State of North Carolina
Department of Environment,
Health and Natural Resources
Division of Solid Waste Management

RE: Upgrade Plan for Existing Groundwater Monitoring System
Carteret County Landfill (Permit #16-02)

Re: Upgrade Plan for Existing Ground-Water Monitoring System
Carteret County Landfill (Permit #16-02)
Carteret County, North Carolina
HDR Project Number: 7908-001-018

CARTERET monitoring system upgrade

Figure
1

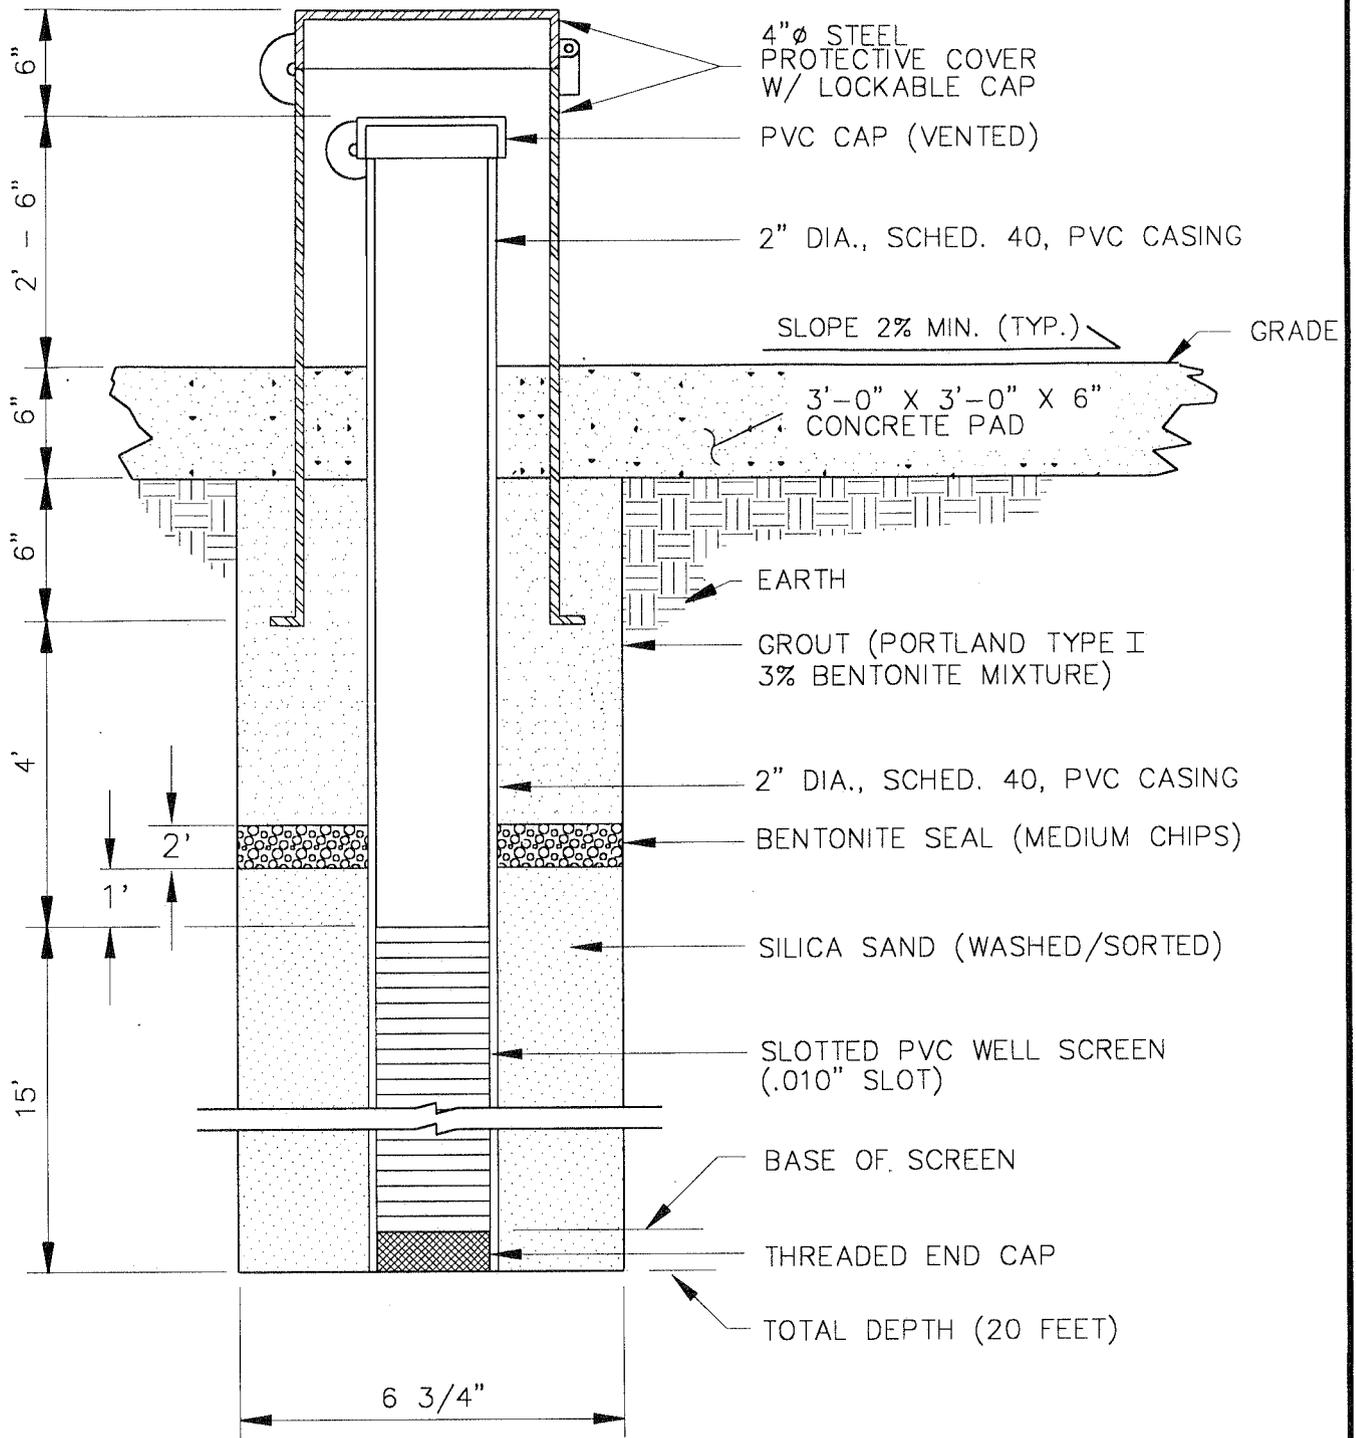
Each well will be installed to an estimated depth of 20 feet below existing land surface using hollow stem augers. In order to ensure that each well is screened within the more permeable sand-bearing unit beneath the site, split spoon samples will be obtained at 5-foot intervals from ground surface. Each well will be constructed with a 15-foot well screen section with 0.010-inch factory slots. All wells will be constructed in accordance with North Carolina Well Construction Standards (NCAC Title 15A, Subchapter 2C, Section 0.100). The attached well construction schematic illustrates the proposed well construction specifications.

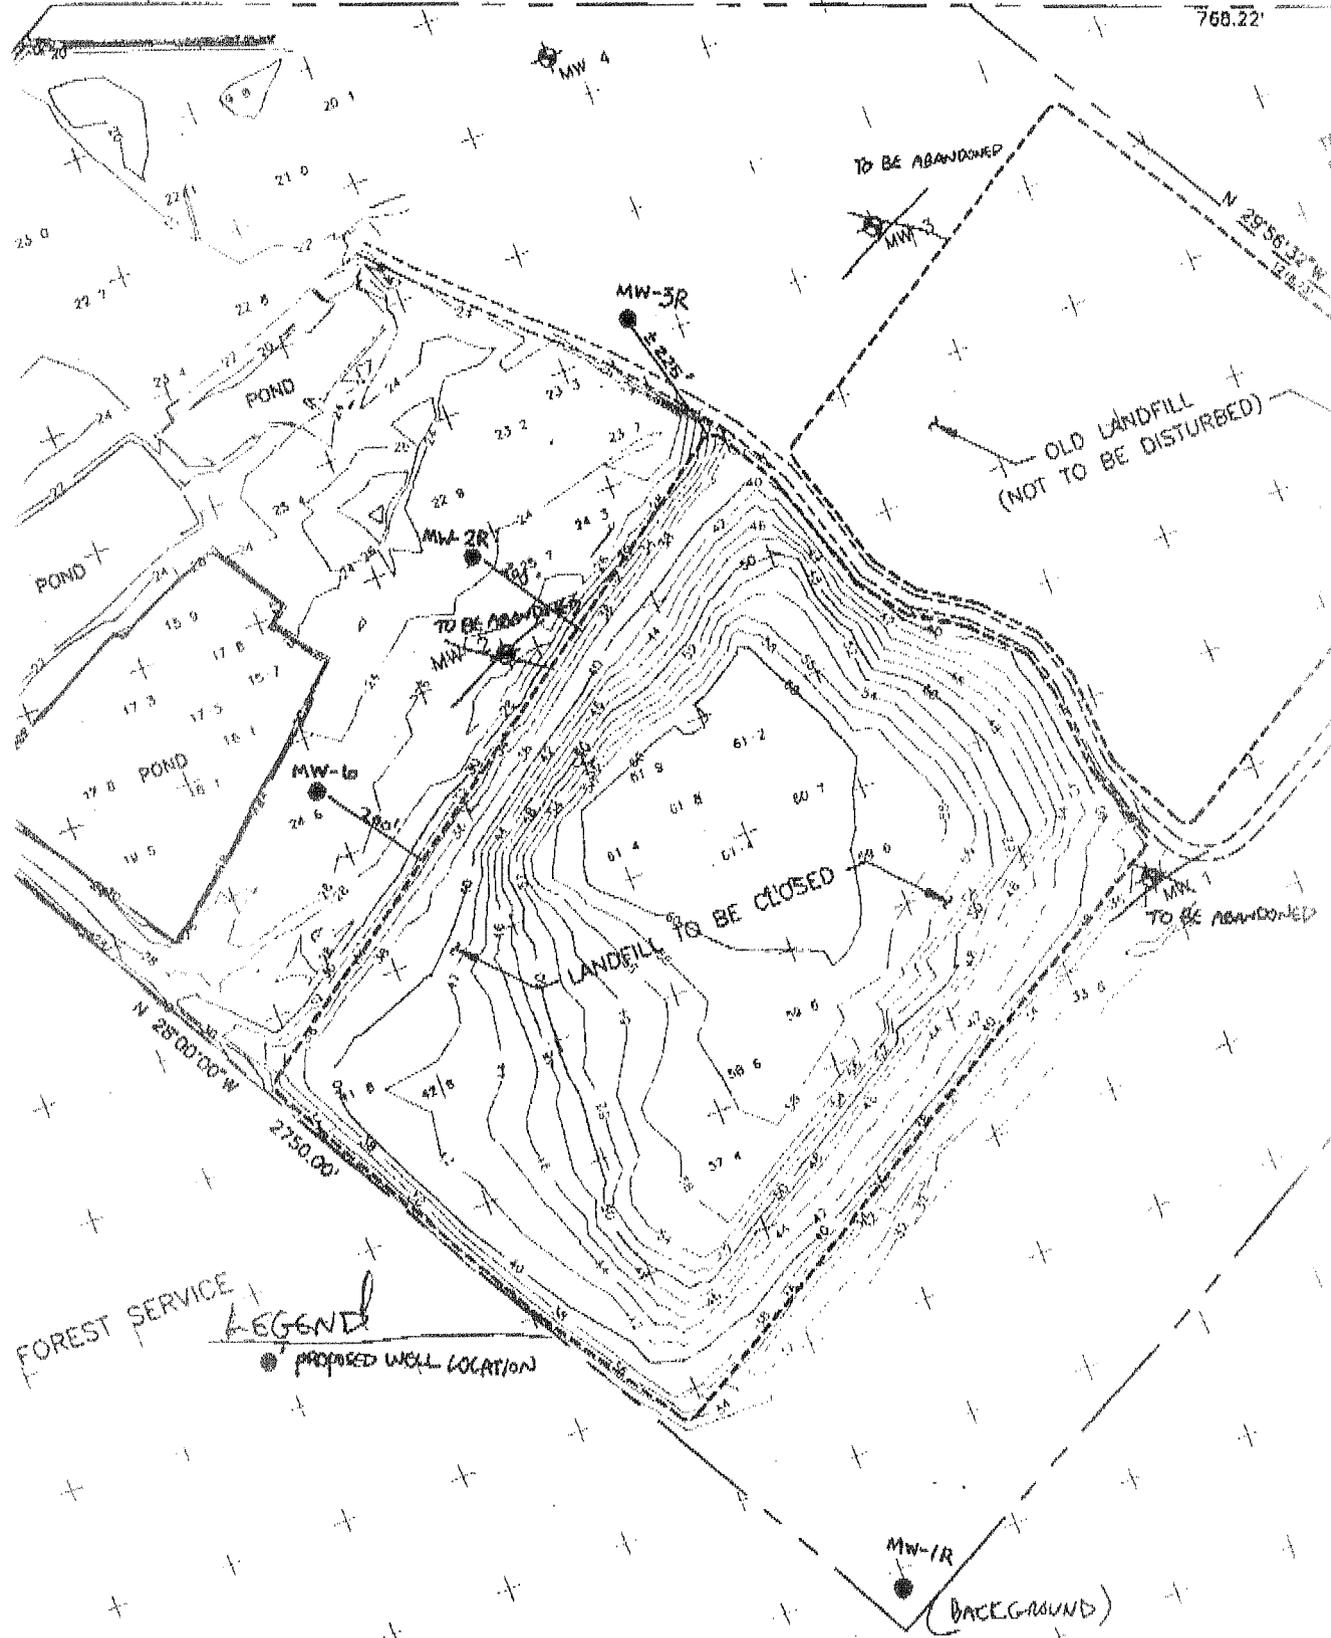
JIM: THE ATTACHED MAP DEPICTS THE PROPOSED LOCATIONS FOR THE REPLACEMENT WELLS AT THE CARTERET COUNTY LANDFILL PURSUANT TO OUR TELEPHONE CONVERSATION ON AUGUST 1, 1995. A NEW ISSUE WAS BROUGHT UP BY THE ENGINEER IN OUR OFFICE CONCERNING THE OLD LANDFILL CELL. SHOULD THE PROPOSED WELL PLACEMENT TAKE INTO CONSIDERATION THE OLD LANDFILL AS WELL AS THE CURRENT PORTION BEING MONITORED. I WILL CALL YOU SHORTLY TO DISCUSS THIS ISSUE BEFORE I FINALIZE THE SUMMARY LETTER OUTLINING CARTERET COUNTY'S INTENTIONS CONCERNING THIS MATTER.

ANY GUIDANCE WILL BE APPRECIATED

2 phone conversations w/ Joan Shan

HE FIXES ATTACHED MAP.

→ OUR ORIGINAL CONSENSUS:

Twin MW-2, 3 WITH 20' WELLS
w/15' SCREENS.

→ His plan on map, but he wondered
if "old landfill" needed downgrad well
(at ~ MW-3)

→ UPSHOT: -Twin MW-3

- FRABBIT 2 wells

From: down grad from

"L.F. to be closed".
